PROPOSED CONSTRUCTION OF TWO DWELLINGS

MITCHELL STREET CLITHEROE

DESIGN AND ACCESS STATEMENT

Date: 20th May 2013
Our Ref. 4325
Version: 1.01

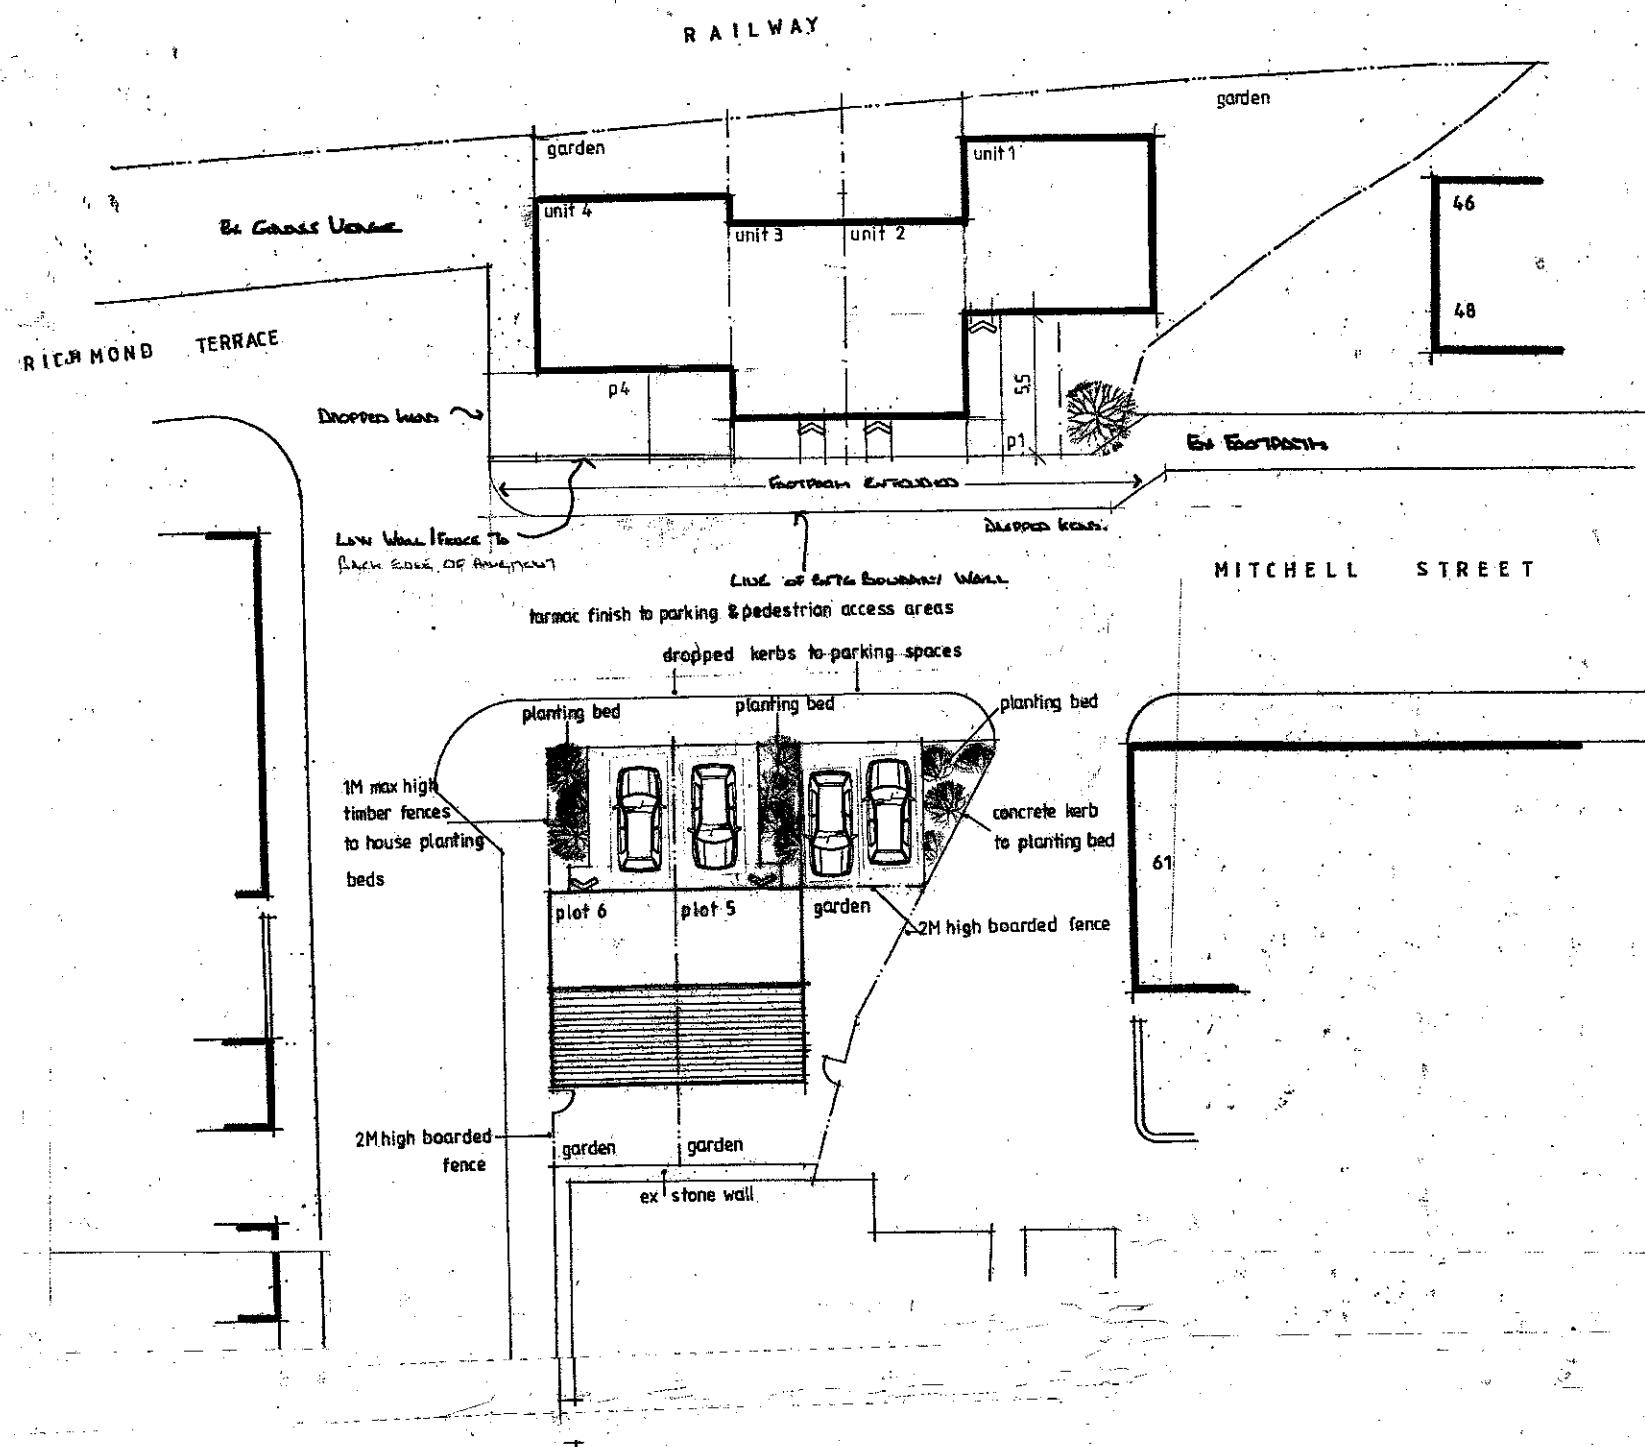
The footway extending to the end of Mitchell Street to Richmond Road / Richmond Terrace, is to provide for people walking along the street, and is not related to access to the proposed dwellings. I would ask for the footway to extend across the Mitchell Street road frontage to Richmond Terrace as requested previously.

Perhaps you might consider an access to a parking space in the front garden from Richmond Terrace. I would not object to this as long as the opportunity to drive out of the parking space across the footway and straight on to Mitchell Street is blocked up by a low wall or similar.

I do not object to the removal of the parking 'layby' on the western side of the carriageway (an extension of the on-street parking outside of No 48). However, the proposed footway extension should extend to the end of Mitchell Street to Richmond Road / Terrace. If there is no access to Unit 4 from Richmond Terrace, then the footway does not need to extend around the corner from Mitchell Street into Richmond Terrace. This will result in parking bay 4 being too short.

There should be a low solid fence or wall only along the Richmond Road side of the parking space 6.

I am satisfied now with the latest amendment to your layout.

I attach Drg Ref 4325-07D which I have amended to provide parking to Unit 4 off Richmond Terrace with the footpath extended as per your comments.

Please note that having finalised the room layouts of Units 5 & 6 the relevant parking spaces have been repositioned to suit.
